WASTE WATER TREATMENT PLANT
AL KASIK MILITARY TRAINING BASE
AL KASIK, IRAQ

SIGIR PA-06-074
JANUARY 29, 2007

SUBJECT: Report on Waste Water Treatment Plant, Al Kasik Military Training Base, Al Kasik, Iraq (Report Number SIGIR PA-06-074)

Diagram 1. Diagram from contractor's submittal A-106 for clarifier torque calculations. The diagram does not show a vertical skimmer arm attached to the sweep arm.

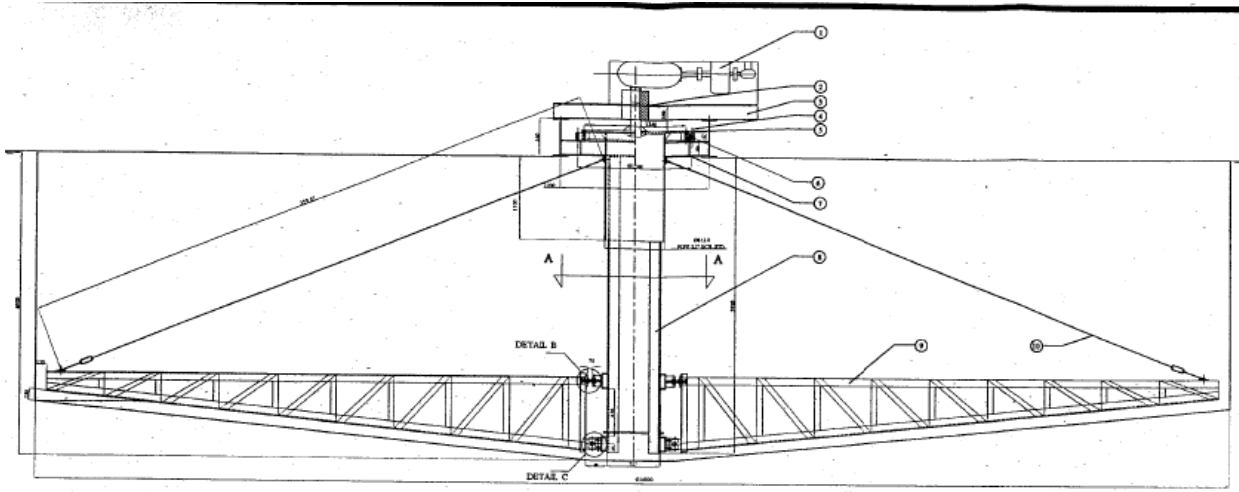
Sweeping occurs when the sweep arm assembly rotates around the bottom of the tank. The diagram below (Diagram 1) shows the approved design for the sweep arm assembly. The sweep arm assembly consists of two horizontal metal sweep arms that are supported by a rotating central shaft. Cables attached to the center shaft support the outer ends of the arms. Sweeping takes place by rubber flaps or scrapers attached to the bottom of each arm. The rubber scrapers are positioned to move the solids on the tank floor as the assembly rotates around the tank.

In that the skimmer structure was not part of the original design, engineering load calculations were likely understated. Changes in the design, such as the addition of the skimmer structure, altered the boundary conditions for the original torque analysis of submittal A-106. The absence of a properly calculated design change to account for the addition of the skimmer structure during construction was likely the catalyst for the series of failures that rendered the clarifier tank inoperable.

Diagram 2.

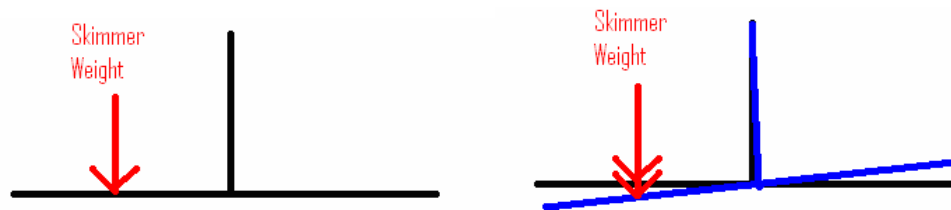
The off center vertical shaft was an indicator of an asymmetrical shaft load. The main shaft moved from center because of an unbalanced load caused by the added weight of the vertical skimmer structure attached during construction to one side of the horizontal scraper arm assembly. Conversely, the opposite side of the horizontal scraper arm assembly did not include a counterweight to offset the weight of the skimmer structure and unbalanced state of the horizontal sweep arm. In addition, an undetermined amount of additional drag force was created as the skimmer structure moved through the tank's liquid while the horizontal sweep arm assembly rotated. Accordingly, the overall load placed on the horizontal sweep arm assembly and drive gearbox likely increased substantially by the addition of the vertical skimmer structure. Simply put, the vertical skimmer structure attached during construction was big and heavy and caused the structure to be unbalanced. Diagram 2 illustrates the movement of the vertical shaft because of the unbalanced load on the horizontal sweep arm assembly. QA Photo 10 presented later in this report shows the skimmer assembly from the top while Site Photo 7 shows the skimmer from inside the tank.

An unbalanced load on the horizontal arm assembly caused stress on the vertical shaft which forced the shaft to an off center position.

Diagram 3. Pump Station G-03 from contractor's piping plan drawing.

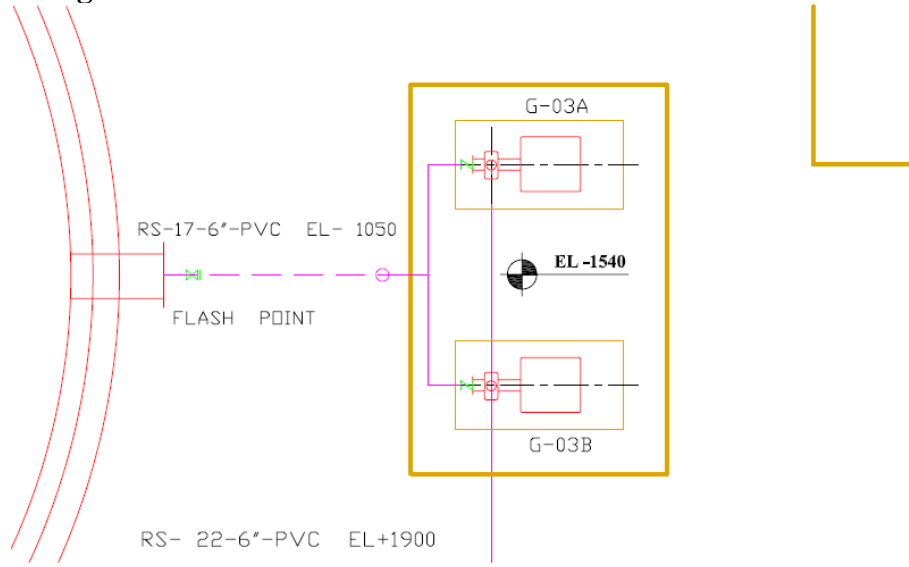
The G-03 pump station located beside the D-07 tank consisted of a below grade reinforced concrete pad with foundation walls. Placing the pumps below grade improved the efficiency of the pumps located on pads identified as G-03A and G-03B in Diagram 3. In addition, the diagram shows the relative location of the pump station in relation to the edge of the D-7 tank. In comparison to many of the concrete structures observed throughout the WWTP, the G-03 pump station was not a large structure. It measured approximately, 4.4 m (14.5 ft) by 2.7 m (9 ft) by 1.7 m (5.6 ft) deep. During the site visit, the assessment team observed significant fractures in the concrete structure along the base, walls, and corners of the G-03 pump station. A series of photos (Site Photos 11-18) illustrate what the assessment team observed while on site. Site Photos 11-16 were taken from inside the pump station while Site Photos 17 and 18 were taken from the outside.

Site Photos 11 and 12 show that sizeable vertical cracks crept up the rear wall of the pump station.

Site Photos 13 and 14 show the horizontal fracturing that occurred near the base of the structure and at a point approximately half way up the wall. The horizontal cracks were generally parallel to each other. Site Photos 15 and 16 show very similar horizontal cracks that wrapped around the opposite corners in the rear wall of the pump station.

During fieldwork discussions, the AFCEE/COR agreed that the pump station should be reconstructed to prevent continued degradation of the pump station and as a hedge against future failure in the G-03 pump station.

Diagram 4. Cross section of G-03 building from the contractor's A-41 submittal.

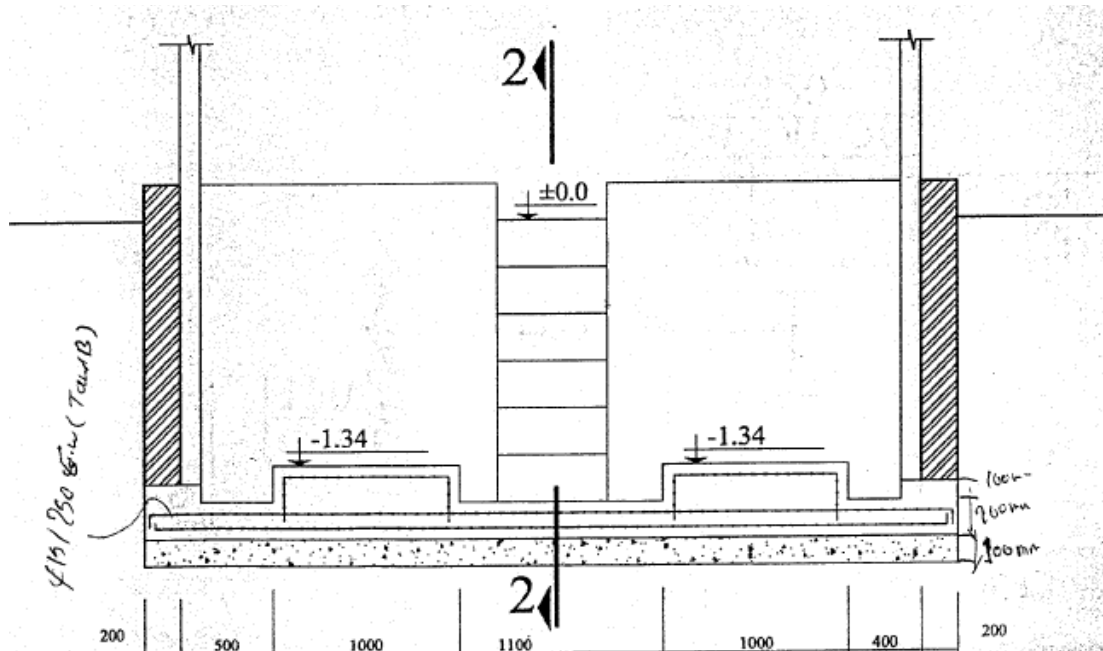
During a review of design and Quality Control documentation, the assessment team found contractor's submittal A-41, G-03 pump pad details, (Diagram 4) with comments that specified the BRC #63 should be replaced with steel bar reinforcement.

Based on the assessment team's observations, a review of design and QC documentation, and discussions conducted with the CMATT/RSU Engineer and the AFCEE/COR, the number of cracks of such magnitude indicated that abnormal stress was distributed across the rear concrete wall of the structure. In addition, such cracks were likely caused by, either/or a combination of, insufficient steel reinforcement of the concrete or inadequate soil compaction. The horizontal cracks that ran from corner to corner of the rear wall indicated that settling of the base slab was very likely. Inadequate soil compaction could cause such settling. Even if properly reinforced, much less if not sufficiently reinforced, the concrete wall would have been prone to cracking if constructed on soil that was not sufficiently compacted.
